CIVIL AERONAUTICS BOARD

Civil Air Regulations Amendment 4b–6, Effective March 5, 1952

PART 4b—AIRPLANE AIRWORTHINESS; TRANSPORT CATEGORIES

MISCELLANEOUS AMENDMENTS

FIGURE 4b–15a—Pictorial definition of angles, dimensions, and directions on a seaplane.

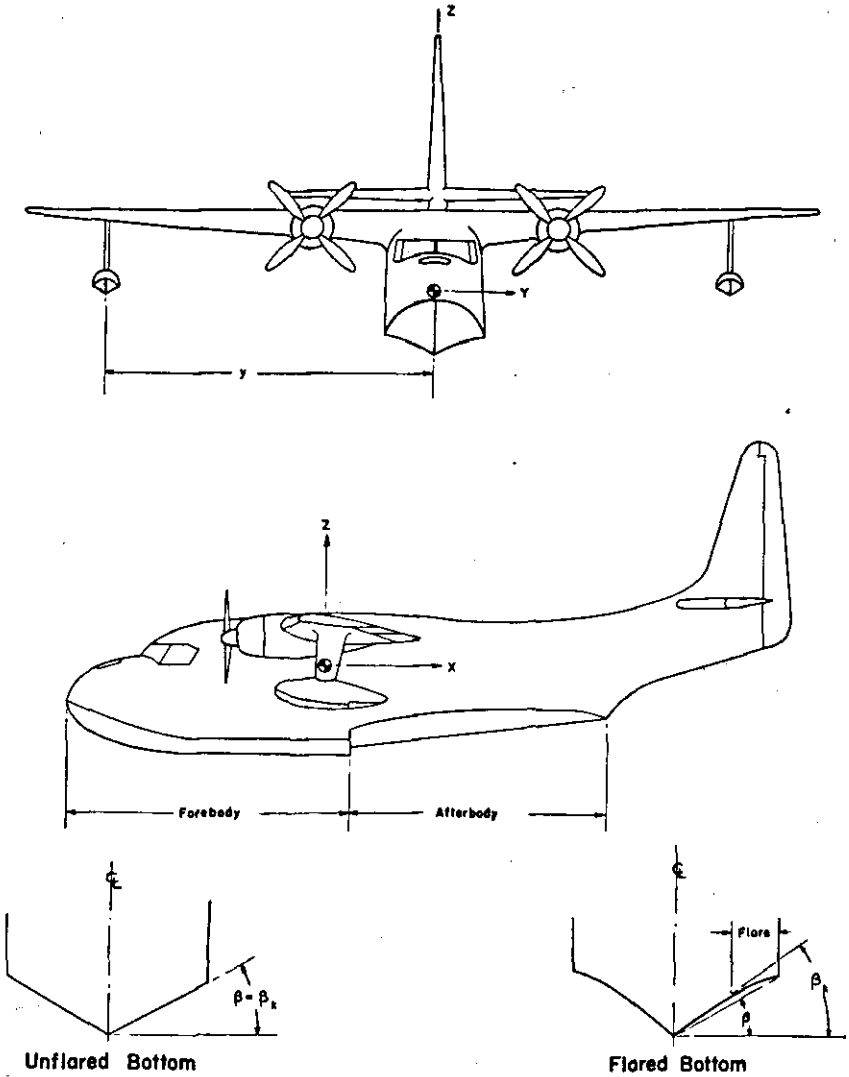
25. By rescinding figure 4b–15 and inserting in lieu thereof new figures 4b–15a, 4b–15b, and 4b–15c and by amending §§ 4b.250 through 4b.257 to read as follows:

P_k = pressure at the keel;
C_2 = 0.0016;
K_2 = hull station weighing factor (see fig. 4b–15b);
V_{s_1} = seaplane stalling speed (mph) at the design take-off weight with flaps extended in the appropriate take-off position;
β_k = angle of dead rise at keel (see fig. 4b–15a).

FIGURE 4b–15b—Hull station weighing factor.

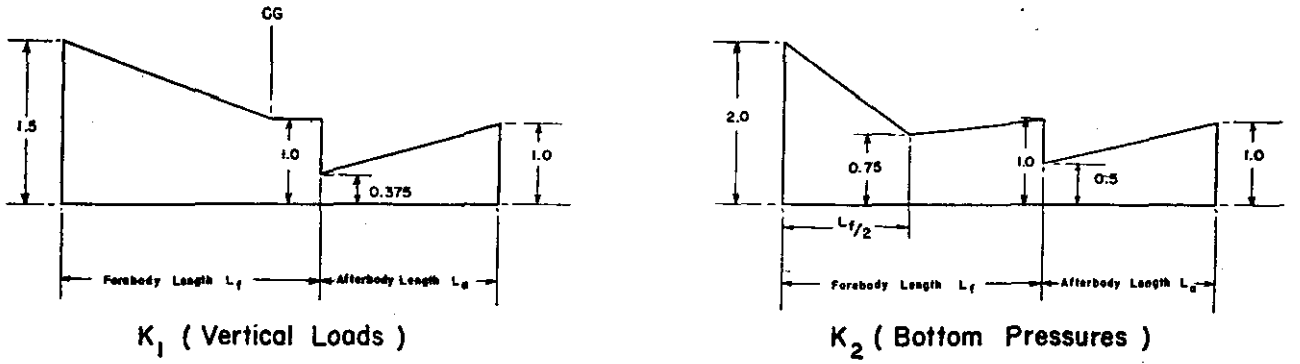
K_1 = empirical hull station weighing factor. (See fig. 4b–15b.) For a twin float seaplane, in recognition of the effect of flexibility of the attachment of the floats to the seaplane, it shall be acceptable to reduce the factor K_1 at the bow and stern to 0.8 of the value shown in figure 4b-15b. This reduction shall not apply to the float design but only to the design of the carry-through and seaplane structure.

P_{ch} = pressure at the chine;
C_3 = 0.0012;
K_2 = hull station weighing factor (see fig. 4b–15b);
V_{s_1} = seaplane stalling speed (mph) at the design take-off weight with flaps extended in the appropriate take-off position;
β = angle of dead rise at appropriate station.

P = pressure;
$C_4=0.078C_1$ (for C_1 see § 4b.253);
K_2 = hull station weighing factor (see fig. 4b–15b);
V_{s_0} = seaplane stalling speed (mph) with landing flaps extended in the appropriate position and with no slipstream effect;
β = angle of dead rise at appropriate station.
